CERTIFICATE OF APPROPRIATENESS

Property: 623 Highland Street, Lot 11, Tract 10, Block 30, Woodland Heights Subdivision. The property includes a historic 2,135 square foot, one-story wood frame single-family residence and detached garage situated on a 7,500 square foot (75' x 100') interior lot.

Proposal: Alteration – The applicant was denied a COA by the Commission at the February 13, 2014 HAHC meeting, to replace 17 original 1-over-1 wood sash windows with 17 new composite sash windows. The applicant has resubmitted the application to replace 17 original 1-over-1 wood sash windows with 17 new 1-over-1 composite sash windows within the same openings.

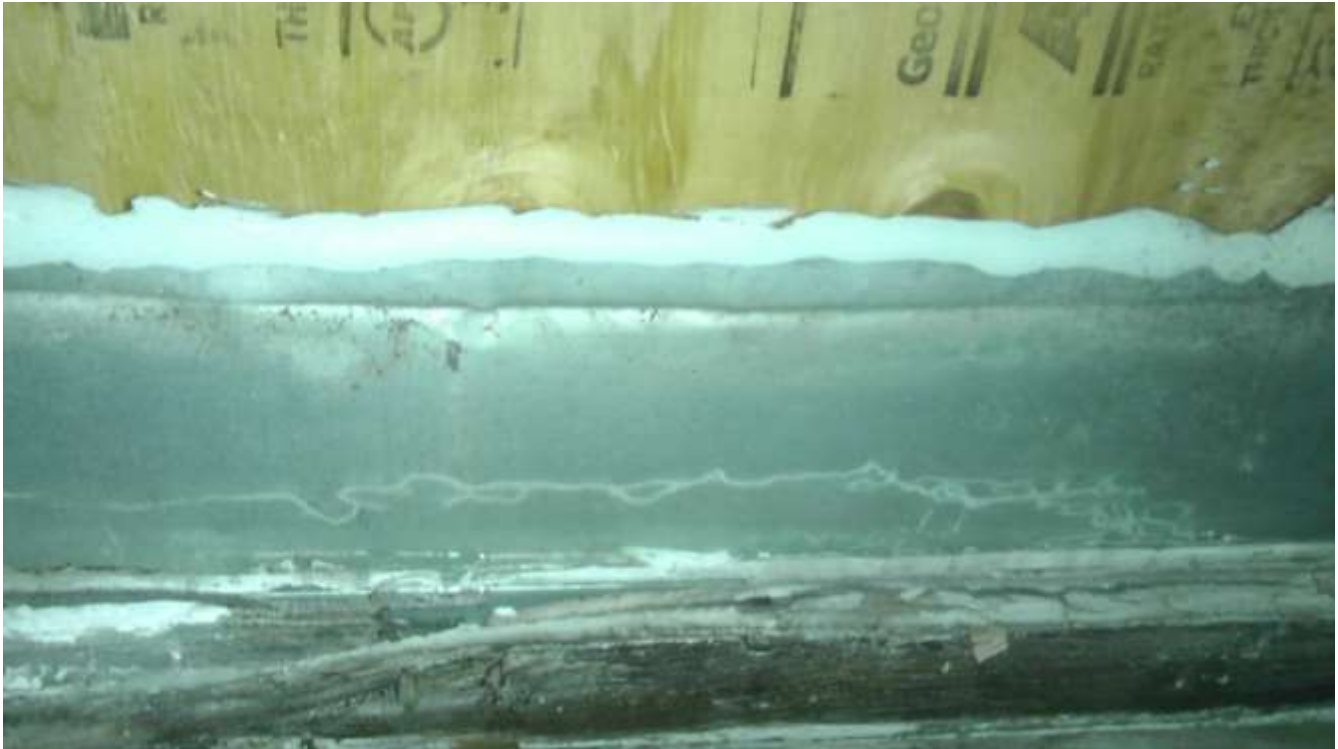
Window 117 has a sagging meeting rail and window 222 shows signs of rot on the bottom sash.

Side Elevation: Replace five 1-over-1 sash windows with five 1-over-1 replacement sash windows.
(East) Window 101 has a sagging meeting rail.
